CENTER FOR NUCLEAR WASTE REGULATORY ANALYSES

CORRECTIVE ACTION REQUEST

CAR No: 96-01

TOP-018 was not complied with in several instances for code related to TSPA.
(See Page 2 of 2.)

Enclosures
SUN ccdf plot
CRAY ccdf plot

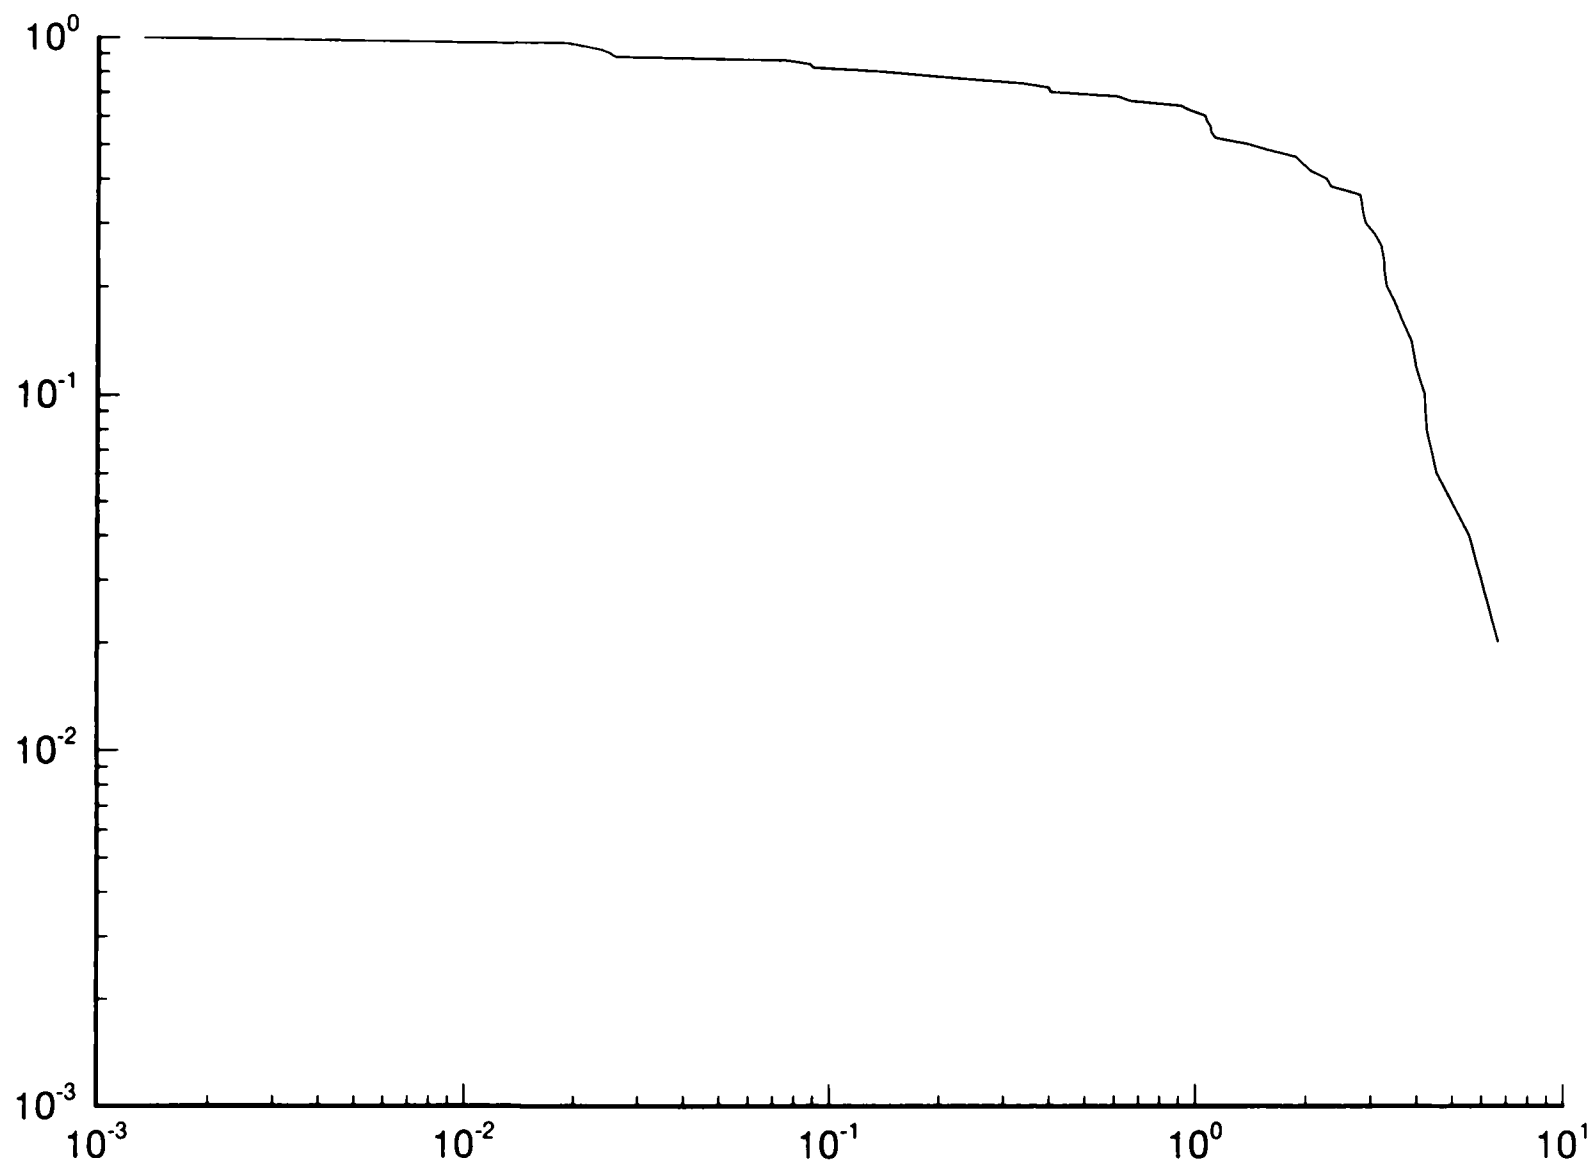
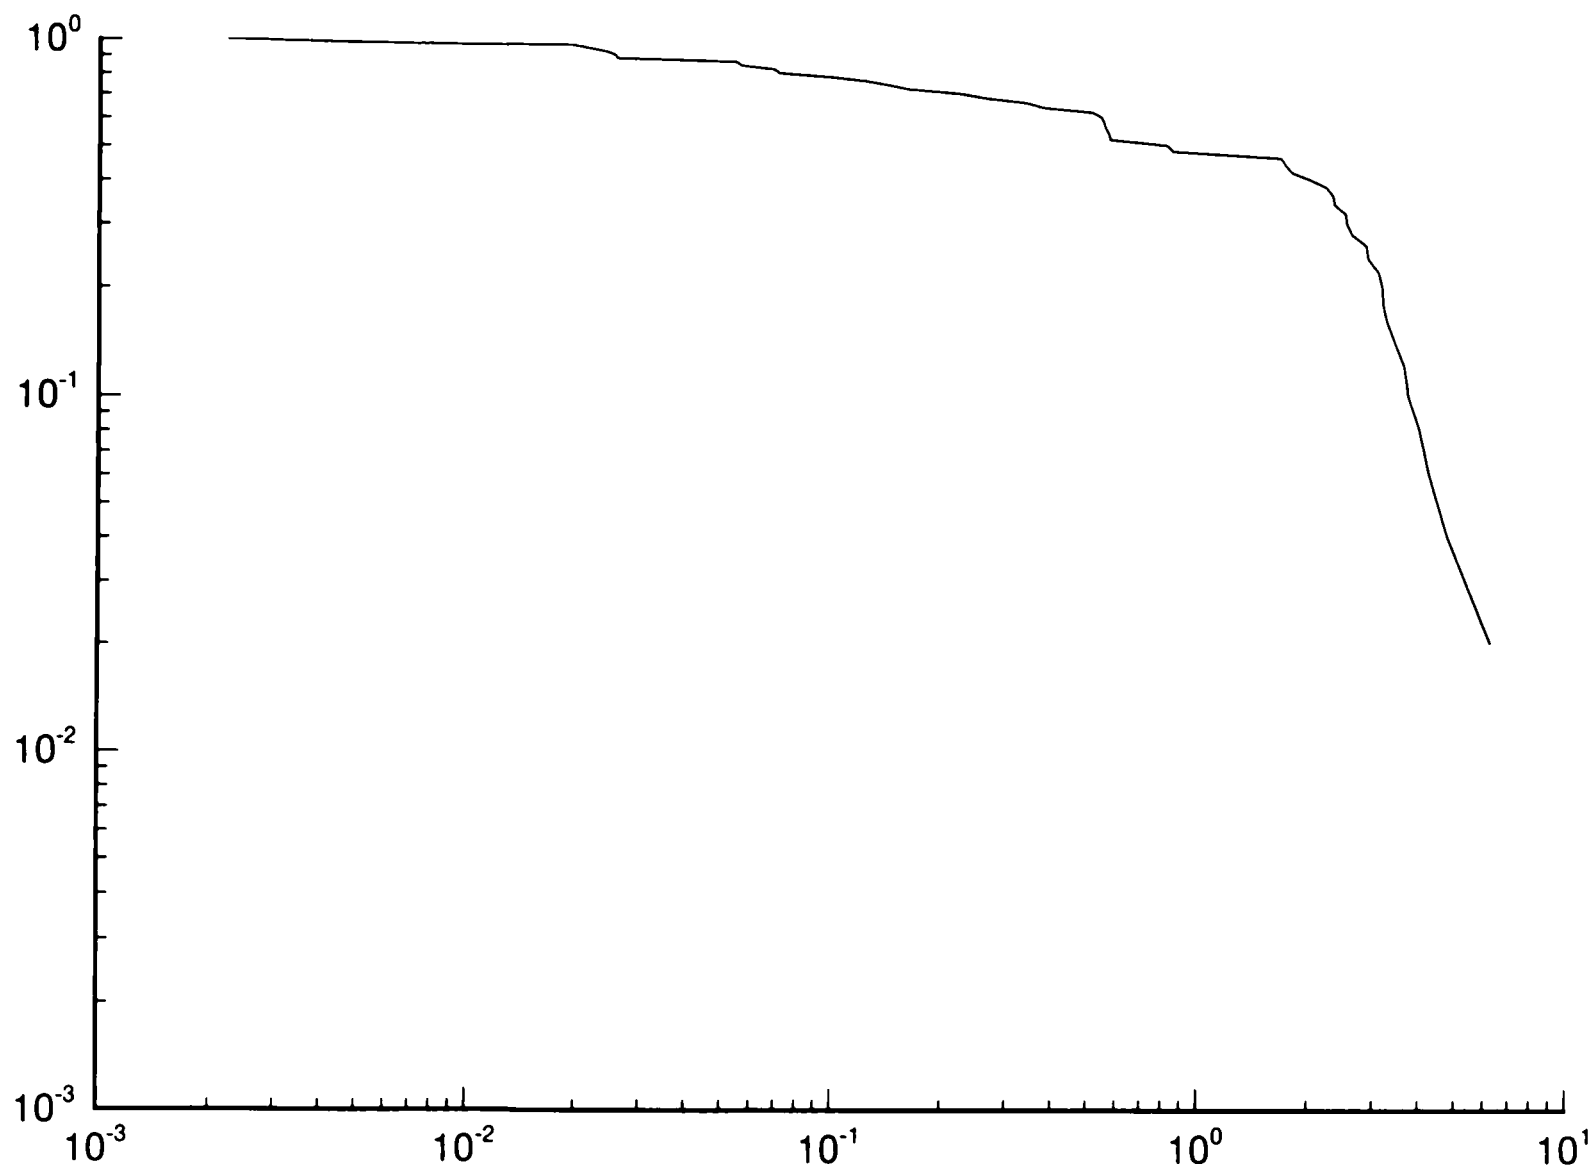
This report is to notify you that the installation test runs performed in 1995 have been located and documented in the TPA scientific notebook. These files indicate an acceptable performance of the SUN instance of TPA version 2 when compared to the original CRAY files. The ccdf output plots are attached to this memo for comparison purposes.

We have compared the graphical results and find that they are sufficiently close to ensure the code on the SUN workstation is functioning in the same manner as the code run on the CRAY supercomputer.
